Groundwater Application Review Summary Form

Application # G- 19275

TO: Water Rights Section Date 06/26/2025
FROM: Groundwater Section Darrick E. Boschmann
Reviewer's Name
SUBJECT: Application G- 19275 Supersedes review of 11/02/2022; 11/08/2024
Date of Review(s)

A. GENERAL INFORMATION: Applicant's Name: Hermreck at the Y Ranch LLC County: Crook

D1. Well #: 1 Logid: CROO 155

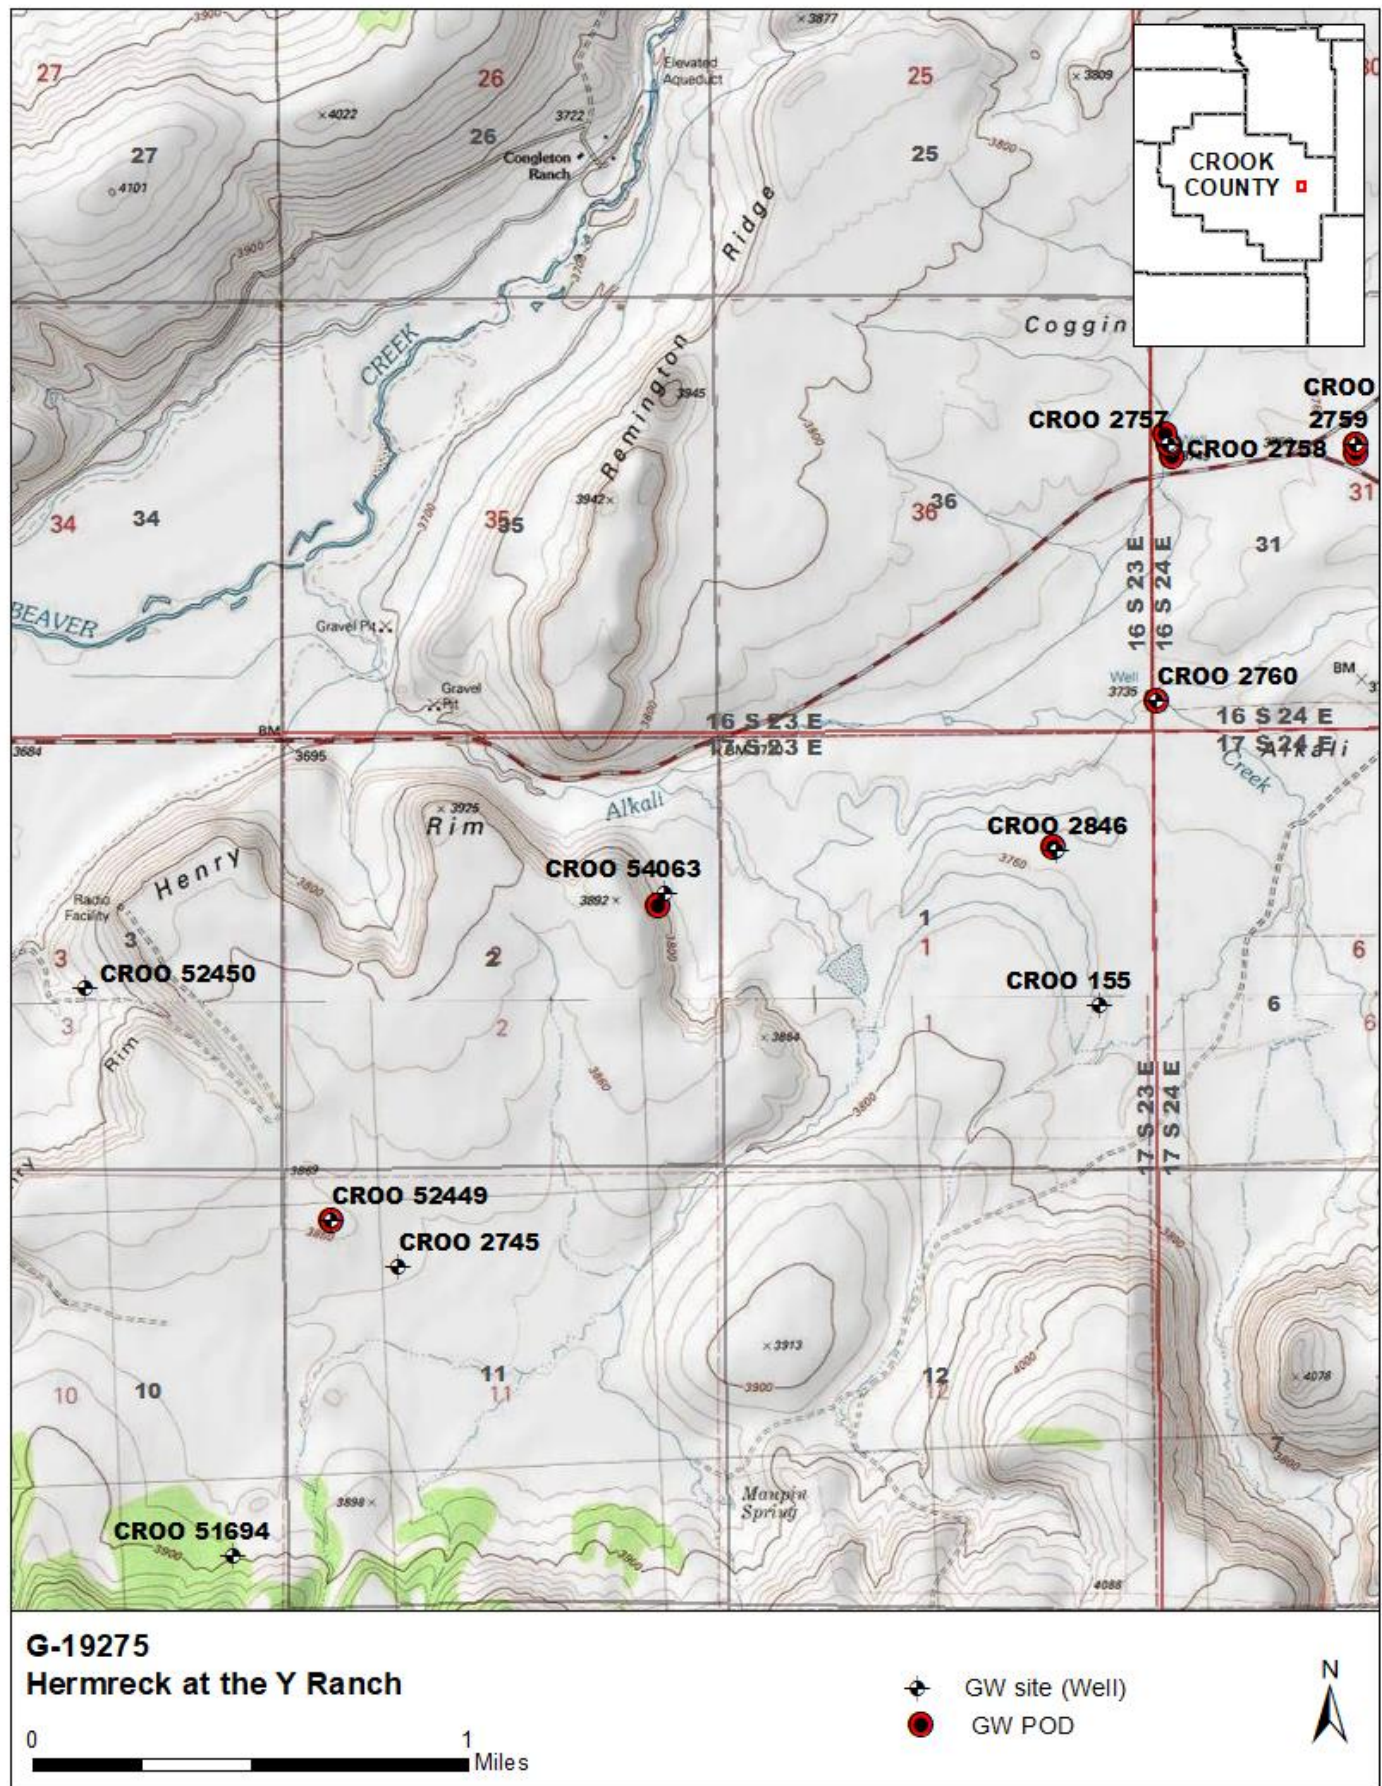
D2. **THE WELL does not appear to meet current well construction standards based upon:**

- a. ☒ review of the well log;
- b. ☐ field inspection by _____;
- c. ☐ report of CWRE _____;
- d. ☐ other: (specify) _____

D3. **THE WELL construction deficiency or other comment is described as follows:** _____

Well report does not indicate the amount of grout used in the well seal.

Based on review of the well log it appears the well is open to two separate aquifers within the Columbia River Basalt Group. The upper aquifer is reported to exist from 160-170 feet blsd; the lower aquifer is reported to exist from 350-362 feet blsd (TD).

D4. ☒ **Route to the Well Construction and Compliance Section for a review of existing well construction.**
